# Product Change Notification

**Change Notification #:** 114650 - 00  
**Change Title:** Intel® Server System R2308GZ4GC  
PCN 114650-00, Product Design,  
Air duct improvement  
**Date of Publication:** May 24, 2016

New air duct lock hook

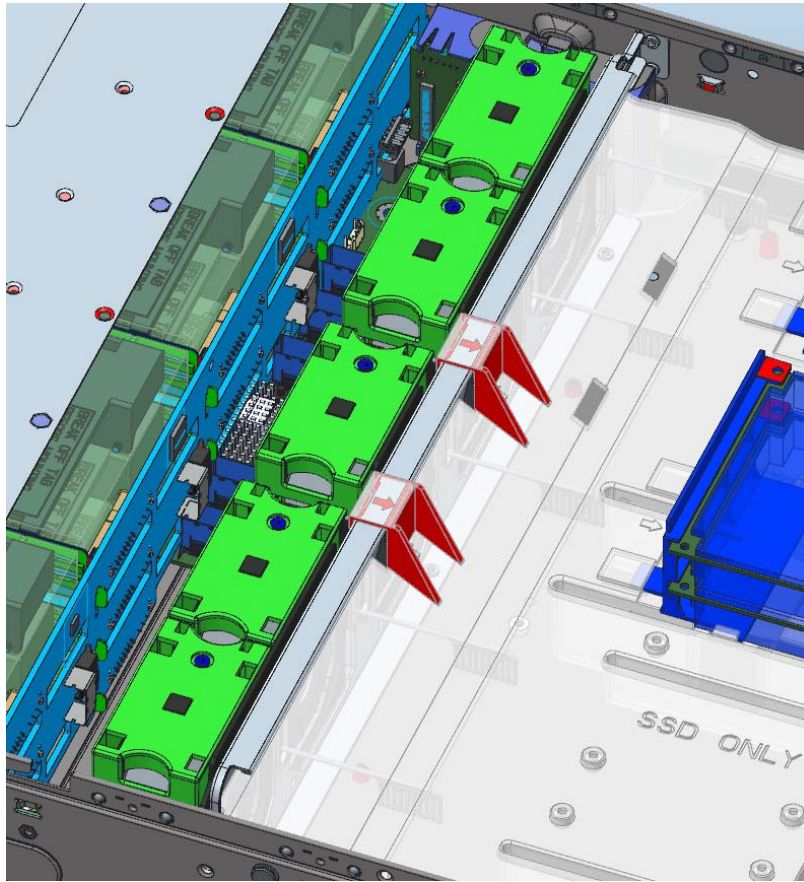
1. Change air duct lock feature: Change air duct lock hook so the air duct will hook over the FAN bulkhead. This will improve the fixing of air duct during transportation.
